Hearings Examiner Public Hearing - Hybrid (In-Person & Electronic) - Phase XII & XIII Preliminary Plat for Villages of Garrison Creek

10:00 AM. Phase XII & XIII Preliminary Plat for Villages of Garrison Creek - Public Hearing - Hybrid (In-Person & Electronic)

A PLANNED UNIT DEVELOPMENT,
LYING IN A PORTION OF THE S1/2 OF THE NE1/4 OF SECTION 36, TOWNSHIP 7 NORTH, RANGE 35 EAST, W.M.,
WALLA WALLA COUNTY, WASHINGTON

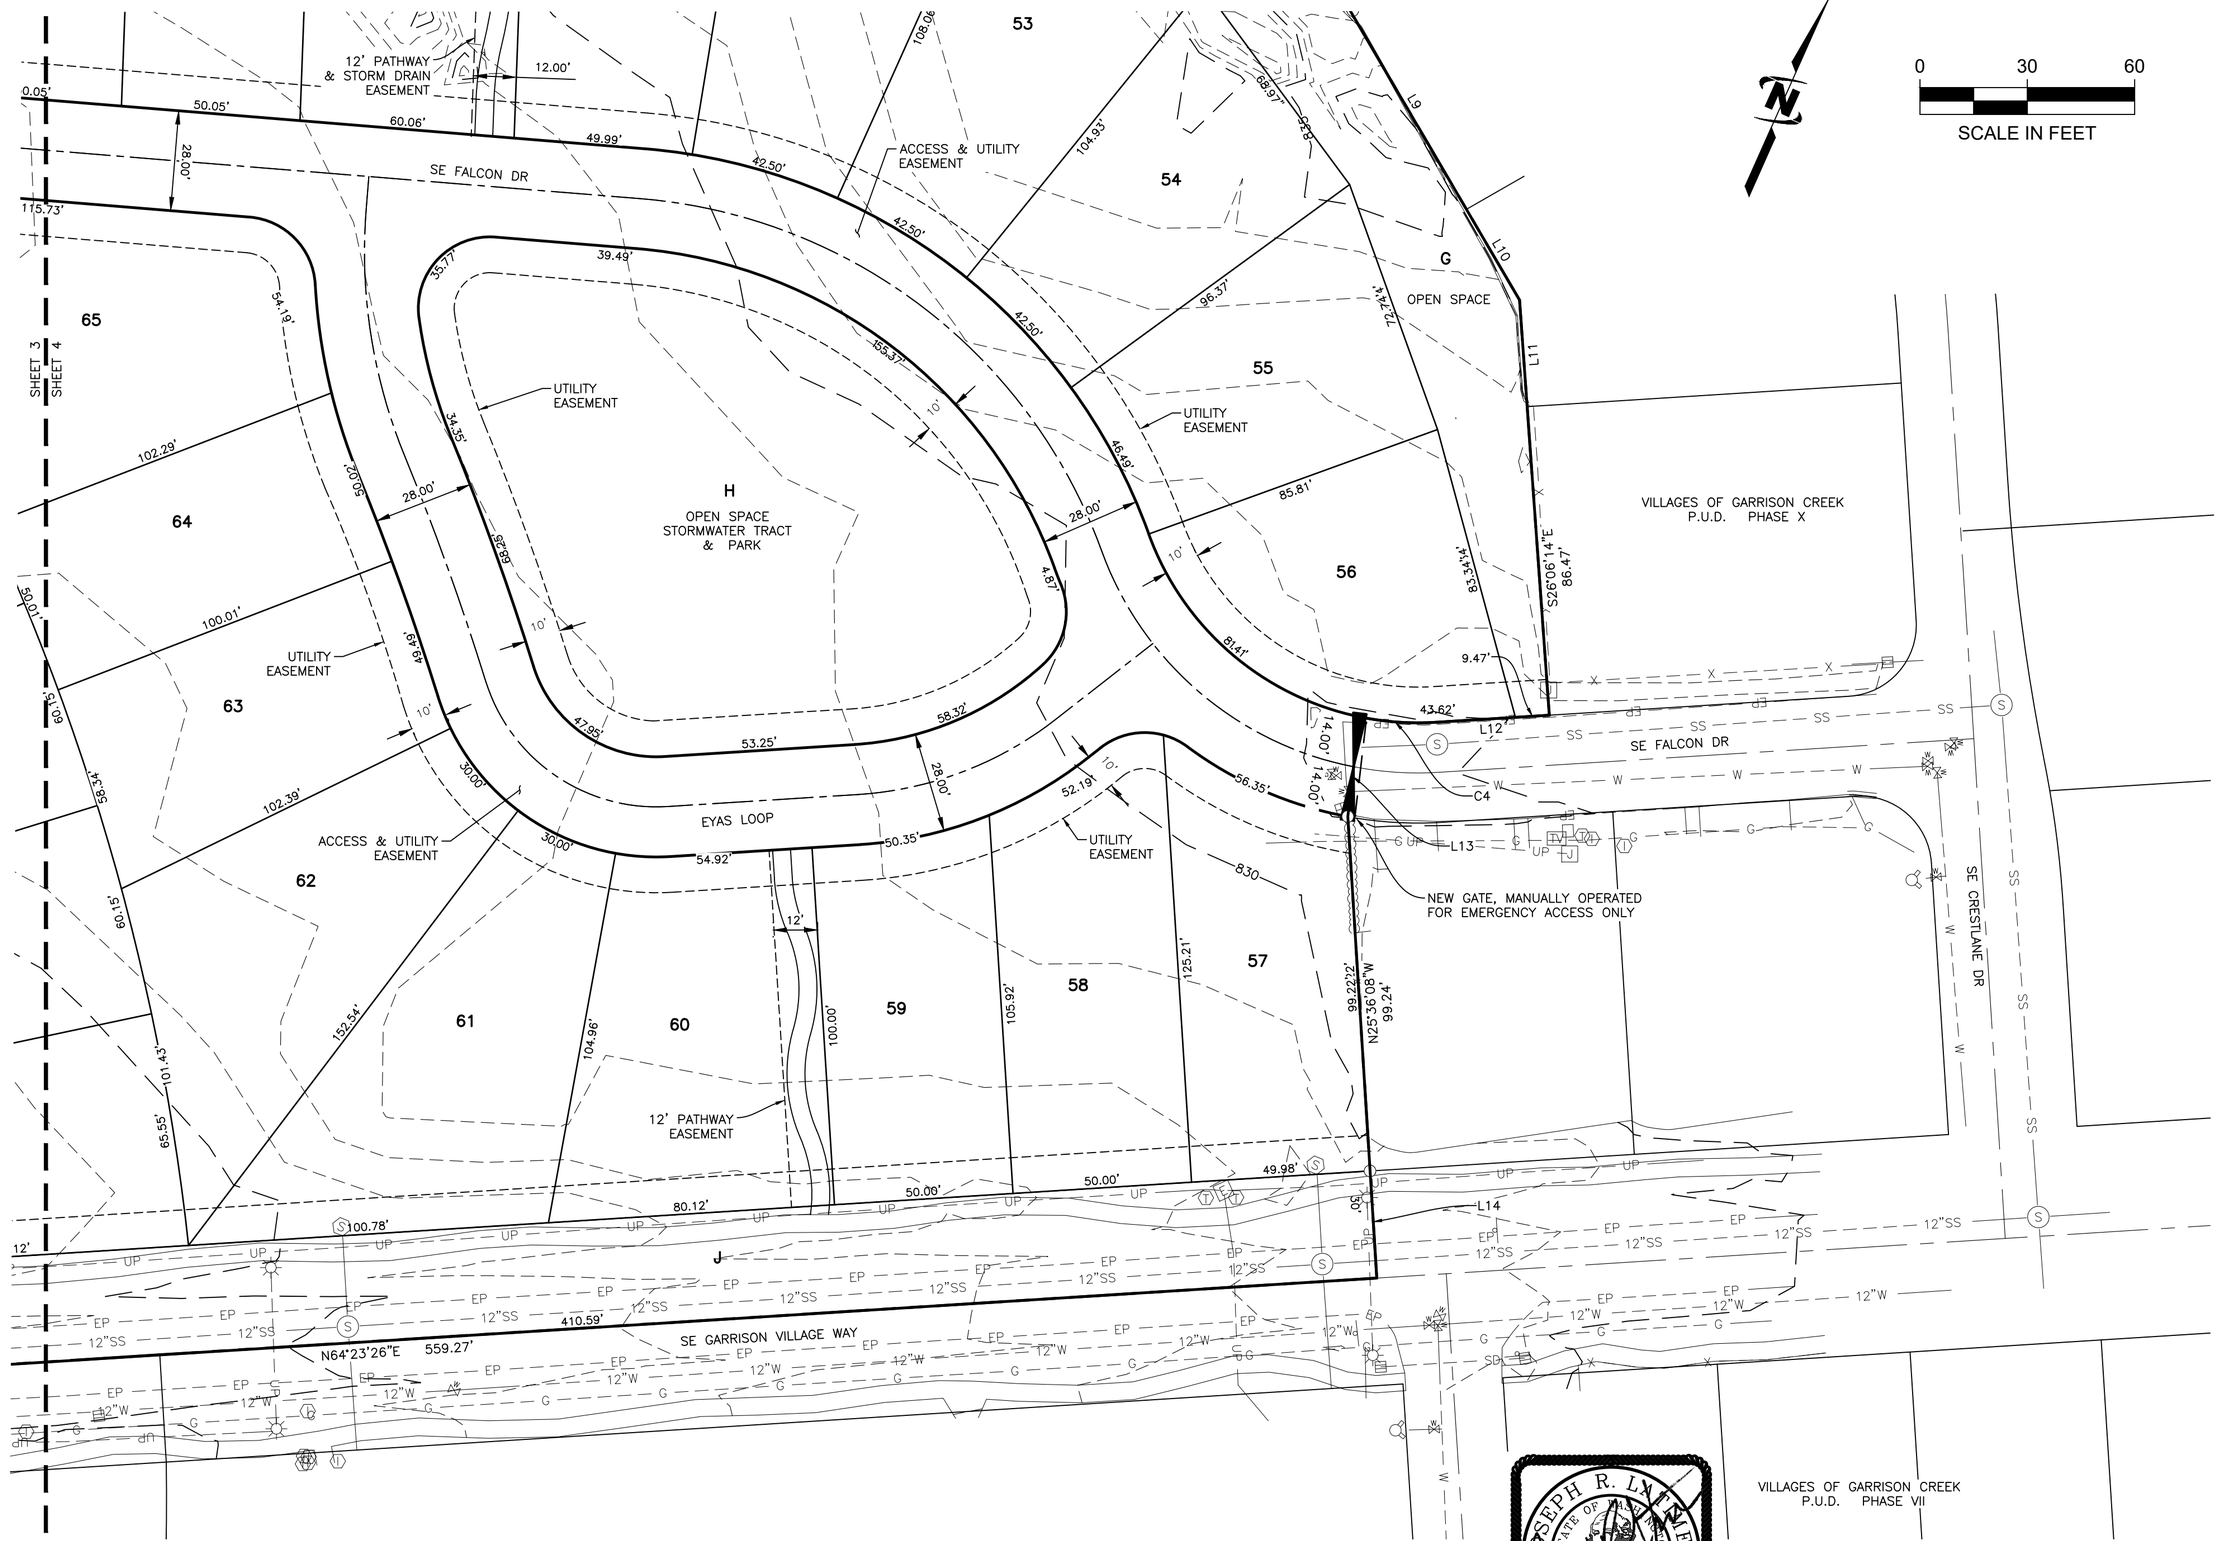
1. Together with the lot line dimensions that are shown, bearings and curve data need to be added to all the lot lines on the final plat. This may require additional curve and line tables.

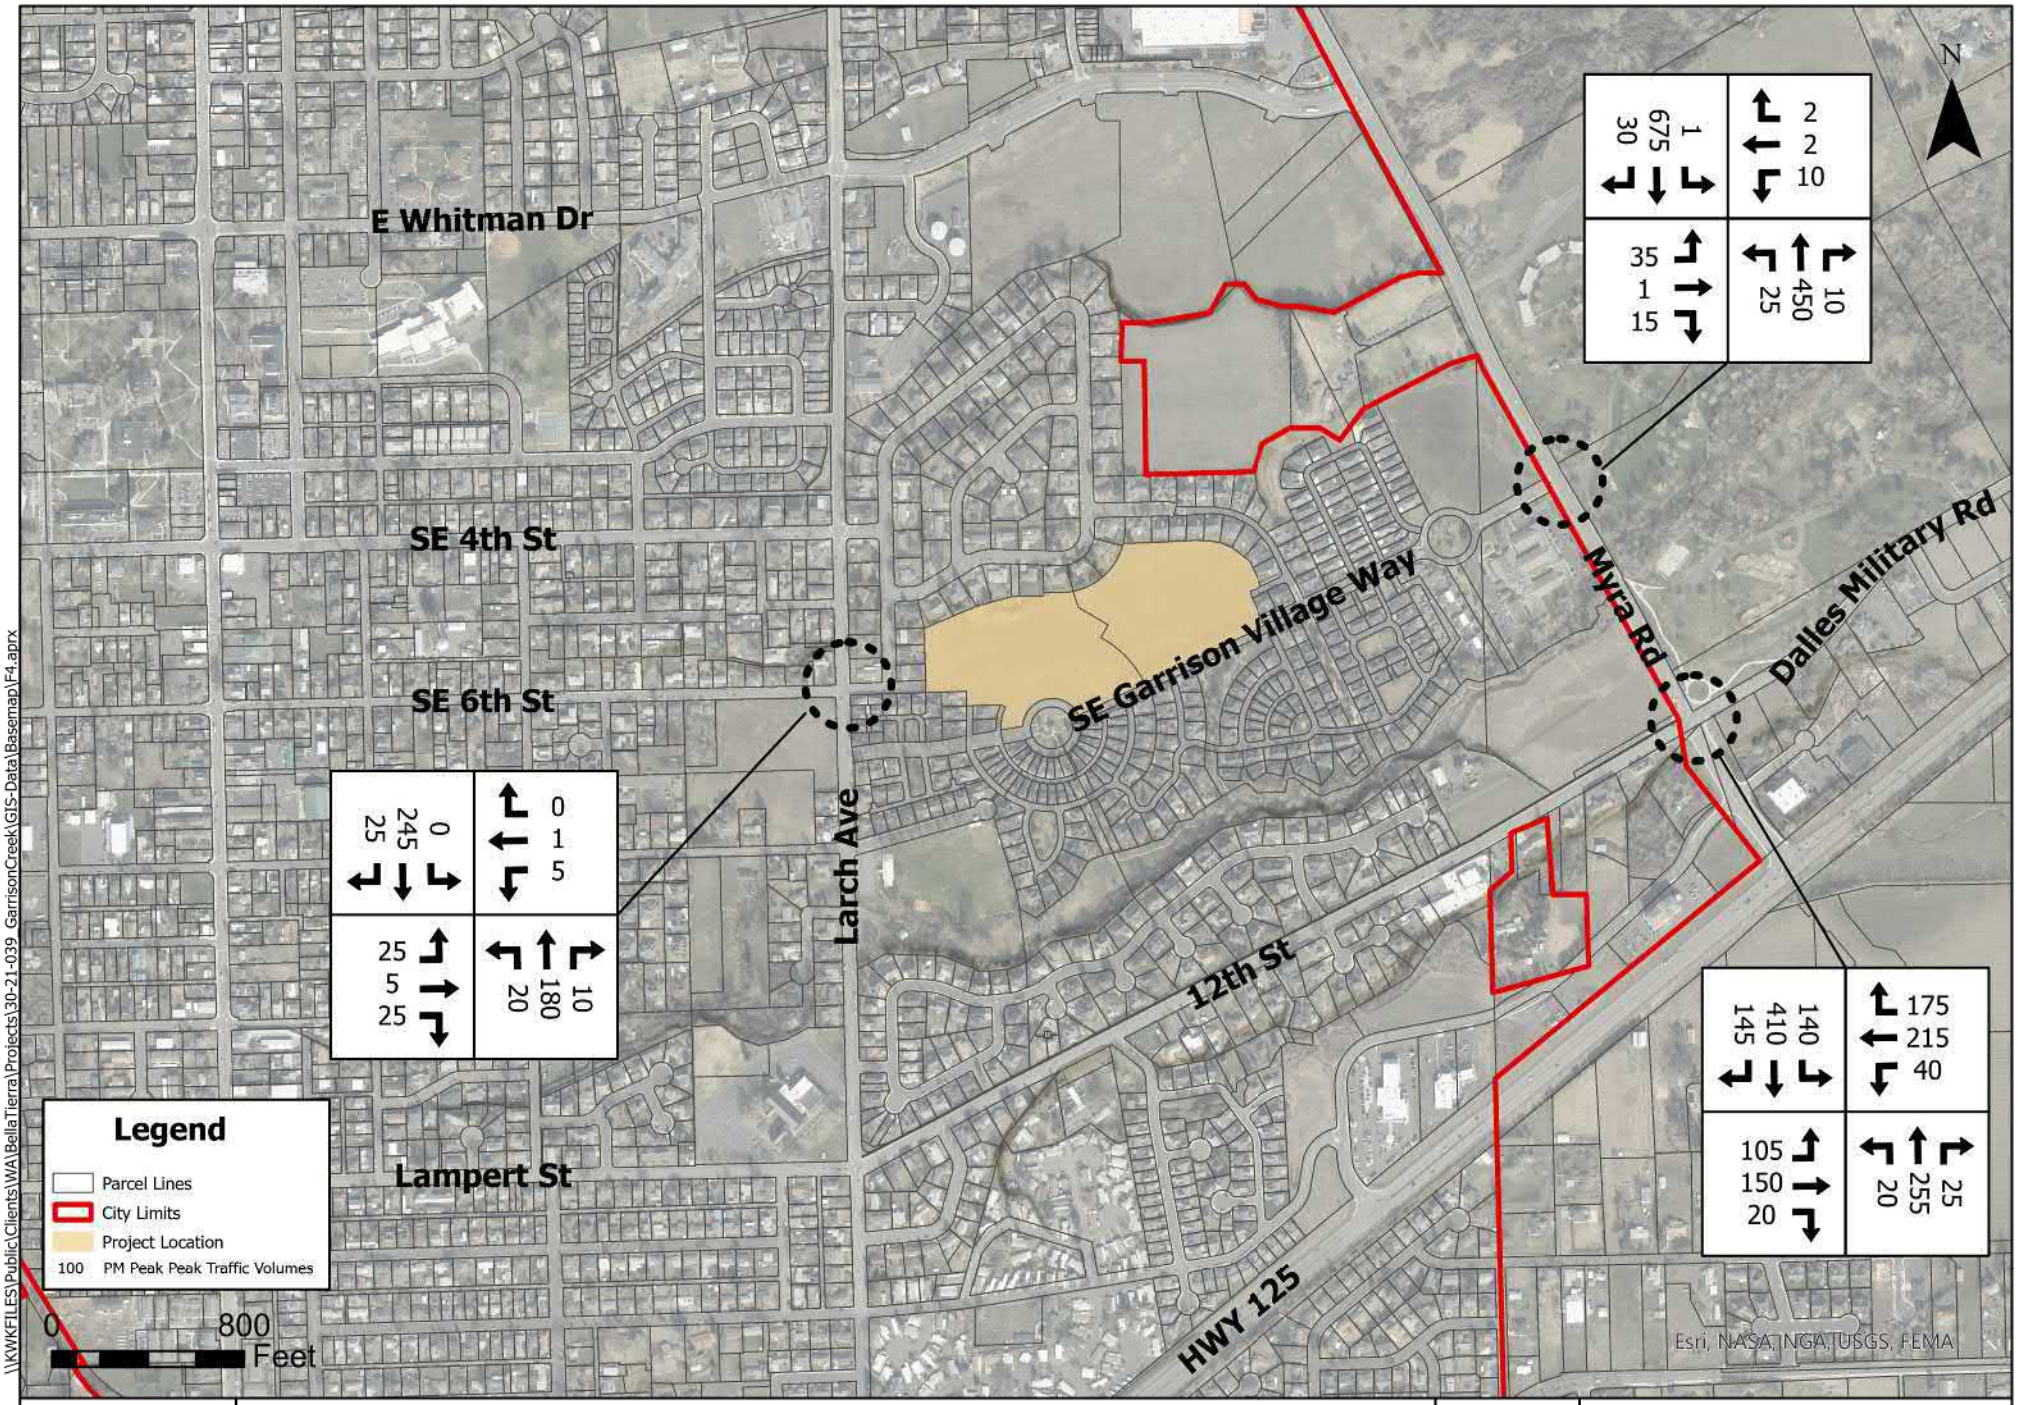
2. As stated in the TIA, future 2027 background volumes included a background growth rate of 1% per year and two in-process developments, Myra-Offner Mixed Use development and the Village at Fort Walla Walla. Looking at Appendix C, the volumes for the No Build 2027 do not add up correctly at the two intersections on Myra Road. For example, the eastbound left on 12th Street at Myra Road is 93 vehicles in Figure 3 (Existing 2022). Background growth at 1% per year to 2027 would add approximately 5 vehicles. Appendix C shows 37 eastbound left vehicles at the intersection being generated by the Village at Fort Walla Walla. This adds up to a total of 135 vehicles for the 2027 No Build scenario. However, the volume shown in

Figure 4 (2027 No Build) only shows 105 vehicles. DKS recommends that the 2027 No Build volumes (specifically the in-process trips) are reviewed and any analysis is updated where necessary, this would include the Build analysis, traffic signal warrants, and turn lane evaluations.

c. TIA Update – Update the J-U-B TIA per the recommendations in the DKS analysis (exhibit 36).
    d. If the traffic signal is still not warranted after DKS Comment #2, Comment #3, and Comment #5 have been addressed, the developer shall pay their proportionate share of the future traffic signal installation at Myra Road/Garrison Village Way. The proportionate share should be calculated per the DKS memo.
